MEMORANDUM

JOB NAME: #17-254022 FA adidas NACCO Warehouse
Portland, OR

RE: Scope and Submission Changes

RE: Scope and Submission Changes

1 FIRST FLOOR PLAN
A-202 1/8" = 1'-0"

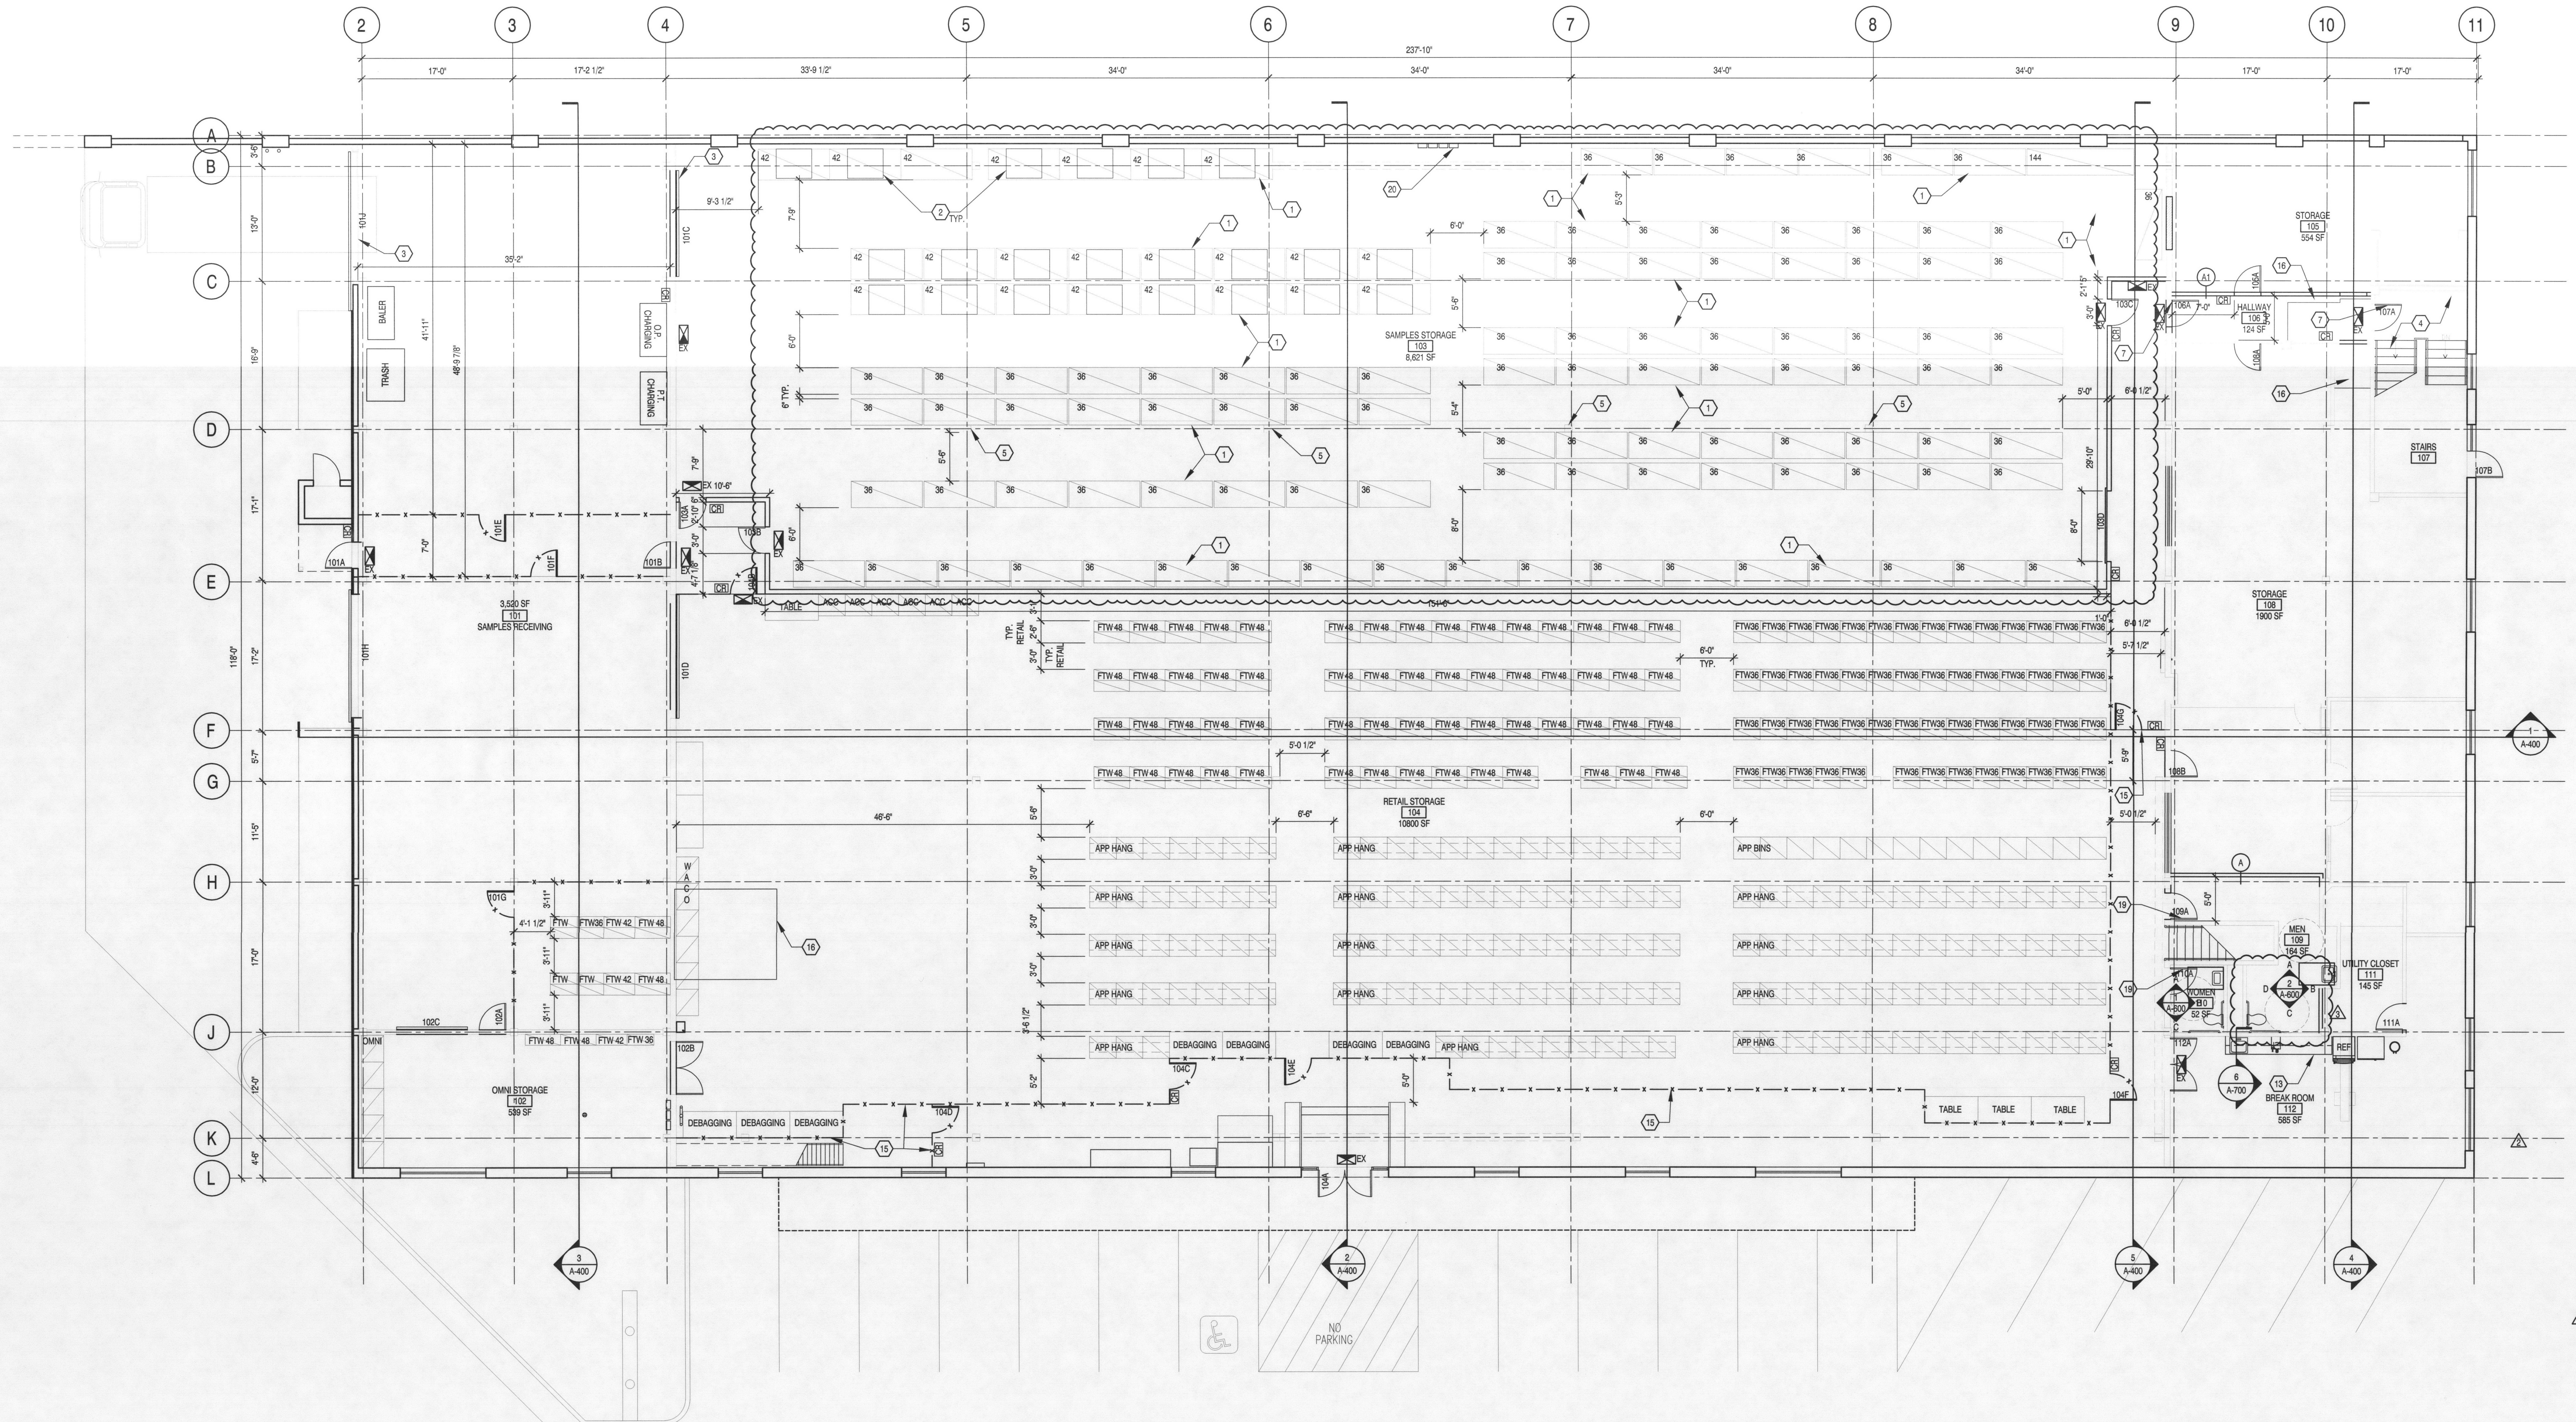
G-101	Modified Egress, calculations
A-101	Modified Parking, parking calculations
A-200	Modified to show full scope
A-202	Modified to show full scope, additional security fence, shelving
A-203	Modified due to scope
A-204	Modified due to scope
A-205	Modified to show full scope
A-206	Modified to show full scope
A-207	Modified to show full scope
A-400	Modified to show full scope, additional security wall
A-500	Removed due to change in security wall
A-600	Modified door schedule
A-700	Modified details

A-200	Revised to show removal of urinal
A-202	Revised to show new racking layout, no partition in men's restroom
A-600	Revised elevations, door schedule
